SUBJECT: COMANCHE PEAK STEAM ELECTRIC STATION (CPSES)- UNIT 1
DOCKET NOS. 50-445
SUBMITTAL OF LICENSE AMENDMENT REQUEST 92-04
UNDERVOLTAGE AND UNDERFREQUENCY CHANGES TO
TABLE 2.2-1 OF THE UNIT 1 TECHNICAL SPECIFICATIONS

DESCRIPTION AND ASSESSMENT

FIGURE 1

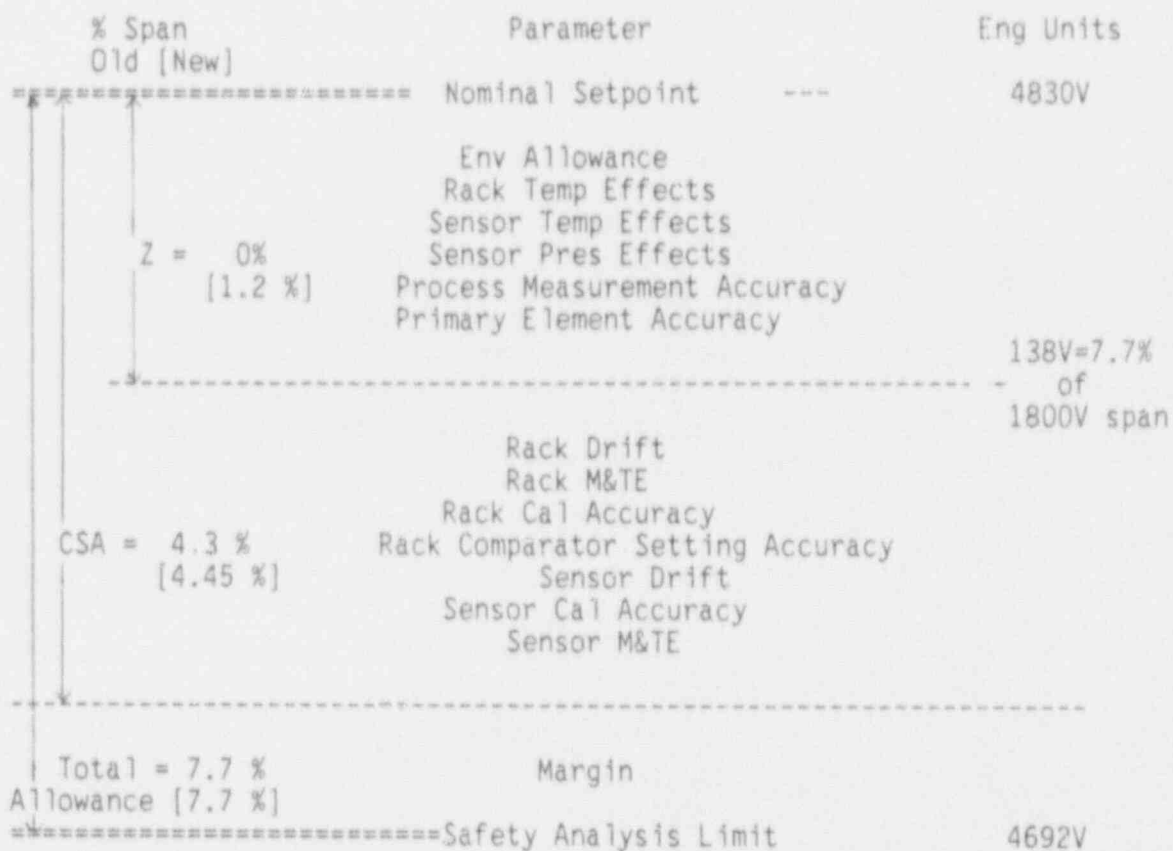
The UV relay senses RCP Bus voltage through a potential transformer. The potential transformer has a primary to secondary winding ratio of 60:1 (7200V:120V) with an uncertainty of 0.3 %. The primary to secondary winding ratio and the associated uncertainty translates to an output voltage, with a 7.2 KV input, of 120 V ± 0.36 V or $\pm 1.2\%$ of span. Incorporating the potential transformer uncertainty changes the Primary Element Accuracy (PEA) of the Westinghouse Setpoint Methodology from 0.0 % to 1.2 % span. The "Z"

value of Table 2.2.1 of the Technical Specifications is defined in the BASES of the Technical Specifications as being the statistical sum³ of the errors assumed in the analysis excluding those associated with the sensor and rack drift as well as the accuracy of their measurement. WCAP-12123 calculates the "Z" value as the sum of the sensor environmental allowance plus the SRSS of the process measurement accuracy, the primary element accuracy, the sensor temperature effects, the sensor pressure effects, and the rack temperature effects (see figure 1). The "Z" term in Table 2.2.1 of the Technical Specifications for item 14 is changed from 0 % to 1.2 % of span. The Channel Statistical Allowance (CSA) for the UV trip, which uses the same terms as the "Z" term, also changes. The changed CSA is still below the Total Allowance of 7.7 % of span which is listed in Table 2.2.1.

In summary, the addition of the potential transformer uncertainty into the UV relay calculations changes the "Z" value listed in Table 2.2.1 of the Technical Specifications for item 14 from 0.0 to 1.2 % of span. Relaxing the tolerance for the UF relays from 1 % to 2 % of span changes the "Allowable Value" column of Table 2.2.1 of the Technical Specifications for item 15 from 57.1 Hz to 57.06 Hz.

Figure 2

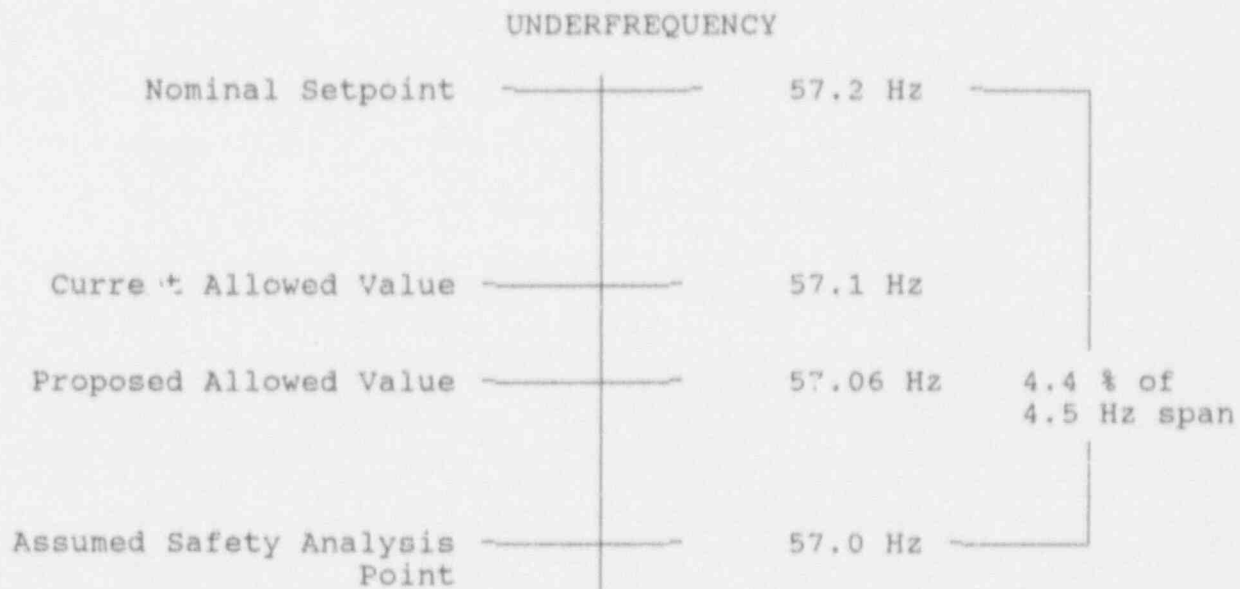
The UF relay monitors the RCP bus frequency and provides backup protection to the UV trip on a complete loss of flow. Westinghouse, in WCAP-12123 assumes that the UF relay is an integral part of the instrument rack and treats the uncertainties as part of the rack uncertainties. Relaxing the UF relay adjustment tolerance from 1 % to 2 % of span will change the various terms used in determining the Channel Statistical Allowance (see figure 2). From the attached TU Electric Reactor Engineering Calculation; "RXE-TA-CP1/0-027, Rev. 1," relaxing the relay adjustment tolerance changes the Rack Calibration Accuracy (RCA) from 1 % to 2 %, the Rack Measuring and Test Equipment (RMTE) allowance from 0.34 % to 0.5 %, and the Channel Statistical Allowance (CSA) from 2.01 % to 3.17 %. The Allowable Value⁴ of Table 2.2.1 of the Technical

specifications is defined in WCAP-12123 as the nominal setpoint plus the arithmetic sum of the instrument uncertainties (ie., rack drift, rack temperature effects, measuring and test equipment allowance, and the rack calibration accuracy). The change in UF relay tolerance, from 1 % to 2 % of span results in an Allowable Value change to Table 2.2.1 of the Technical Specifications for item 15 from 57.1 Hz to 57.06 Hz. Although the Allowable Value for the UF relay is closer to the Nominal setpoint assumed in the accident analysis and the CSA increases from 2.01 % to 3.17 % of span, the Total Allowance (TA)⁵, at 4.4 % of span, is still greater than the CSA.
